HEARING DATE: March 7, 2024

TO: Planning & Zoning Commission

SUBJECT: Rosalyn Subdivision
[H-2023-0056](#)

LOCATION: 200 E. Rosalyn Drive (Parcel #'s R7699020020 and R2114050060)

C. Preliminary Plat/Final Plat (dated: 2/19/2024 & 2/19/2024)

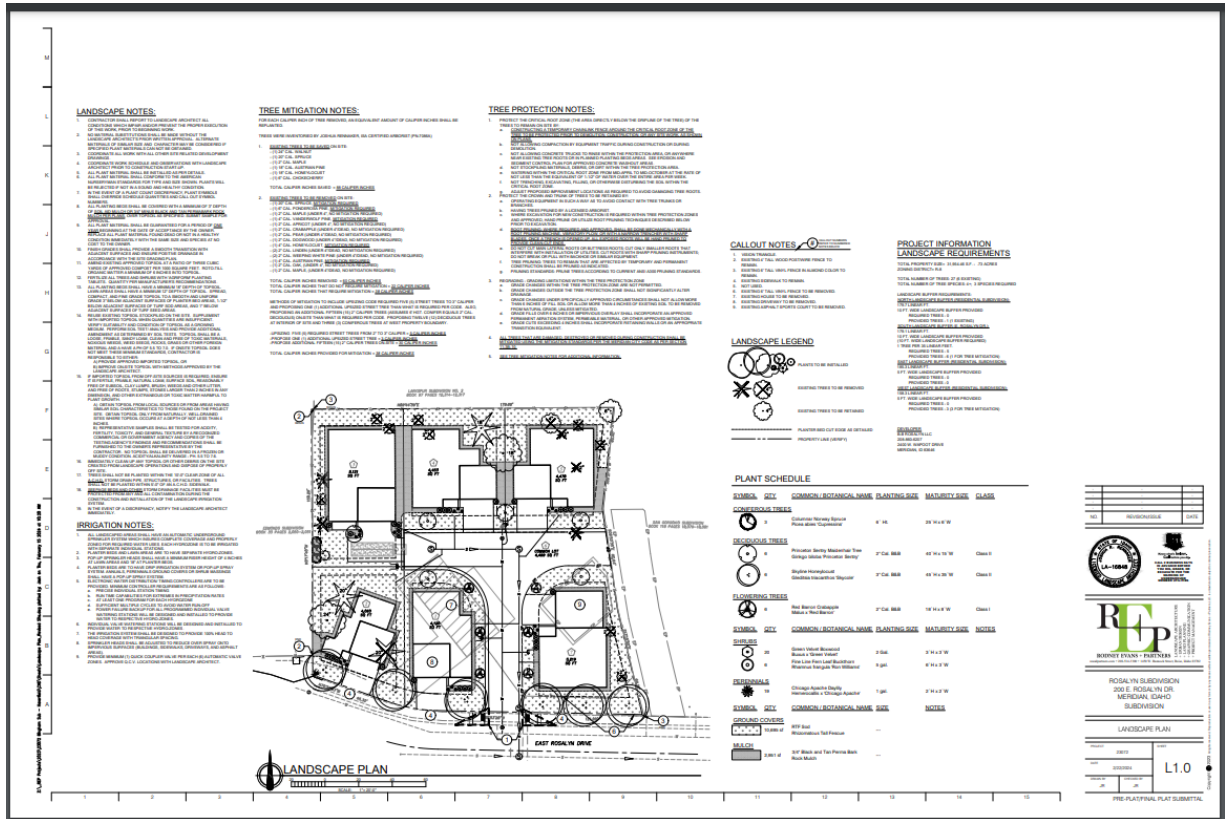
The proposed preliminary plat consists of 6 building lots and 1 common lot on a 0.733-acre property in the existing R-8 zoning district. Proposed lots range in size from 4,060 to 5,219 square feet (s.f.) (or 0.093 to 0.12 acres). The subdivision is proposed to develop in one phase as shown in Section VIII.C.

Dimensional Standards (UDC 11-2): The proposed plat and subsequent development are required to comply with the dimensional standards listed in UDC [Table 11-2A-6](#) for the R-8 zoning district. **The proposed plat appears to comply with the dimensional standards of the district.** Per UDC 11-2A-3B.3, lots taking access from a common drive do not require street frontage.

Access: Access is proposed from E. Rosalyn Drive and a common driveway on Lot 6, Block 1. The interior Lots 3, 4, 5, and 7 Block 1 are proposed to take access via a common drive to E. Rosalyn Drive, meeting the street access requirements of UDC 11-3A-3A.

Common Driveways ([UDC 11-6C-3D](#)): Common driveways shall serve a maximum of four (4) dwelling units. In no case shall more than three (3) dwelling units be located on one (1) side of the driveway. **The Applicant is proposing six (6) dwelling units with four (4) taking access off the common driveway, three (3) dwelling units are also located on one (1) side of the driveway in accordance with the UDC requirements.**

1. Future development of this site shall be generally consistent with the preliminary plat, landscape plan, and conceptual building elevations included in Section VIII and the provisions contained herein.

2. The final plat prepared and signed by Darin Holzhey with Mason and Associates on 2/19/2024 is approved as submitted.
3. The landscape plan prepared by Joshua R. Rennaker with Rodney Evans + Partners on 2/22/2024 is approved as submitted.

4. The proposed plat and subsequent development are required to comply with the dimensional standards listed in UDC Table 11-2A-6 for the R-8 zoning district.

5. Prior to the City Engineer's signature on the final plat, all existing structures that do not conform to the setbacks of the R-8 zoning district shall be removed.
